# UNITED STATES PATENT AND TRADEMARK OFFICE

APPLICATION NO.	FILING DATE	FIRST NAMED INVENTOR	ATTORNEY DOCKET NO.	CONFIRMATION NO.
10/806,520	03/23/2004	Kalyan C. Cherukuri	TI-36594	2743
23494	7590	11/23/2005	EXAMINER	
TEXAS INSTRUMENTS INCORPORATED			NGUYEN, THINH T	
P O BOX 655474, M/S 3999			ART UNIT	
DALLAS, TX 75265			PAPER NUMBER	
			2818

**Office Action Summary**

### **DETAILED OFFICE ACTION**

FIG. 3A

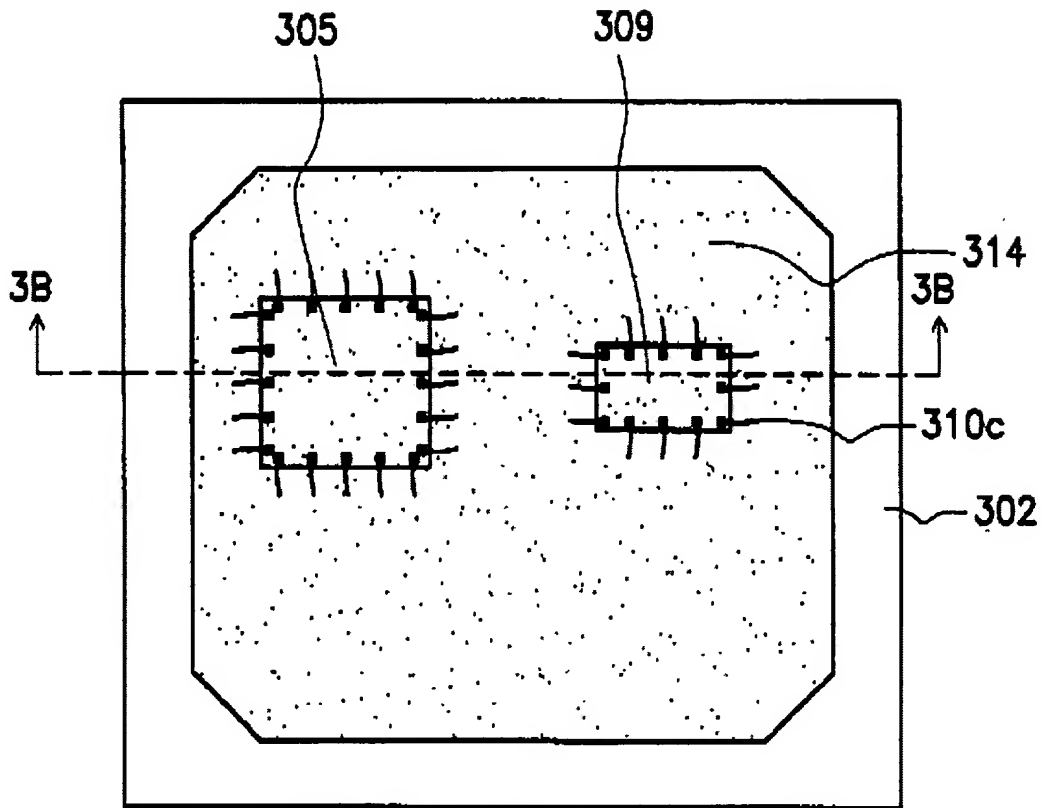
Her discloses ( in the abstract, fig 3A,fig 3B) a semiconductor device comprising: a substrate ( fig 3B,reference 302) having conductive interconnections; two or more vertically stacked chips on said substrate, each supporting chip having metal standoffs ( fig 3B, reference 320a ,320b,column 4 lines 28-32) thereon to separate it from the next successive chip; and a plurality of bond wires connecting at least one chip to said substrate.

Her discloses ( in the abstract, fig 3A,fig 3B,reference 320a,320b,column 4 lines 28-32)

A semiconductor device wherein the metal standoff are thermally conductive.

Her discloses ( in the abstract, fig 3A,fig 3B,) a semiconductor device wherein the metal standoff are surrounded by bond pads.

Her discloses ( in the abstract, fig 3A,fig 3B,) a semiconductor device wherein the bonds wires connect more than one chip to the substrate.

Her discloses ( in the abstract, fig 3A,fig 3B,) a semiconductor device wherein the substrate is a BGA ( Ball Grid Array ) package substrate.

Her discloses ( in the abstract, fig 3A,fig 3B) a semiconductor device wherein the metal standoffs have uniform height.

FIG. 5  
PRIOR ART

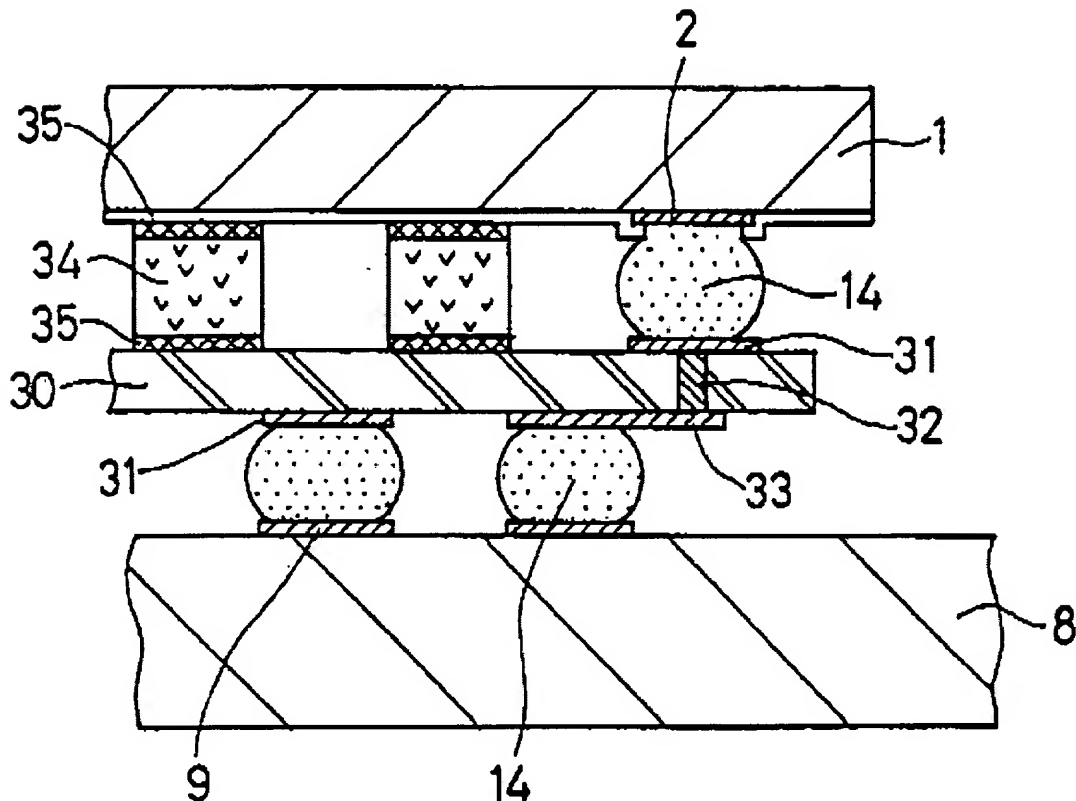
Her et al. ( in the abstract, fig 3A,and fig 3B,column 4 lines 18-32) disclose all the invention including metallic islands standoff except for going into specific details that the metal standoff comprises aluminum islands. This feature, however, is considered obvious because the use of aluminum standoff is old and well known in the art. as evidenced by the disclosure by Baba (US patent 6,016,013 fig 5 and column 2 lines 1-4)

A person skilled in the art at the time the invention was made would be able to use the teachings by Her and his own routine design skill and come up with the invention of claim 2

FIG. 5

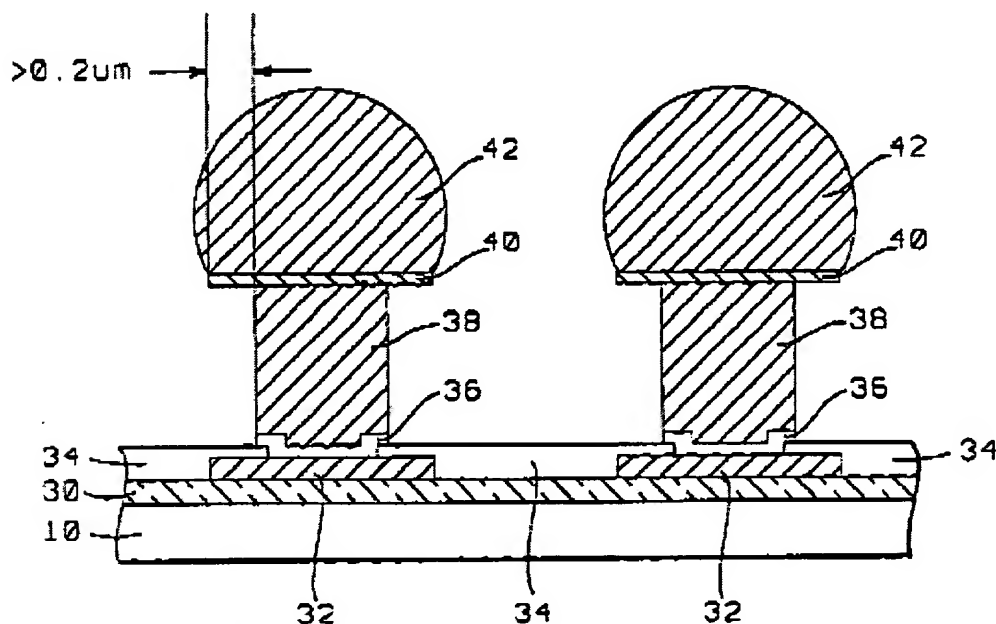
Her et al. ( in the abstract, fig 3A, and fig 3B, column 4 lines 18-32) disclose all the invention except going into detail about a passivation layer on top of a substrate.

This feature, however, is considered obvious since the use of a passivation layer on top of a substrate is old and well known in the art as evidenced by the disclosure by Lee et al. (US patent 6,818,545) in fig 5, in column 6 lines 30-36.
